## Product Change Notice (PCN)

PCN Number: PCN-0456751R-01

Product(s) Affected: MJ-2508

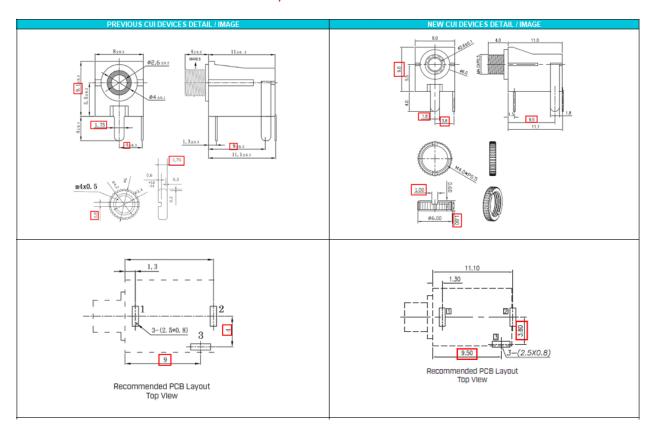
Description of Change: New Factory Location. Product re-engineered for improved manufacturability and production yield. See image below for reference and check CUI Devices website for updated drawing on or after **09/10/2024**. Cosmetic differences may be visible and not affect the form fit and function of the product

DESCRIPTION	MATERIAL	PLATING/COLOR	-	DESCRIPTION	MATERIAL	PLATING/COLOR
terminal 1	brass	tin	_	terminal 1	brass t=0.40	tin over nickel
terminal 2	brass	tin	_	terminal 2	phosphor bronze t=U.2U	tin over nickel
terminal 3	brass	tin	_	terminal 3	brass t=0.40	tin over nickel
bushing	brass	tin	_	bushing	copper alloy	nickel
housing	PBT (UL94V-0)	black	_	housing	PBT (UL94V-0)	black
nut	zinc alloy	nickel	_	nut	copper alloy	nickel

Affected Date Code: All orders placed before **09/10/2024** will be pre-PCN parts. Orders placed after **09/10/2024** will be manufactured in accordance with the PCN. Please check updated 2D drawing on or after **09/10/2024**.
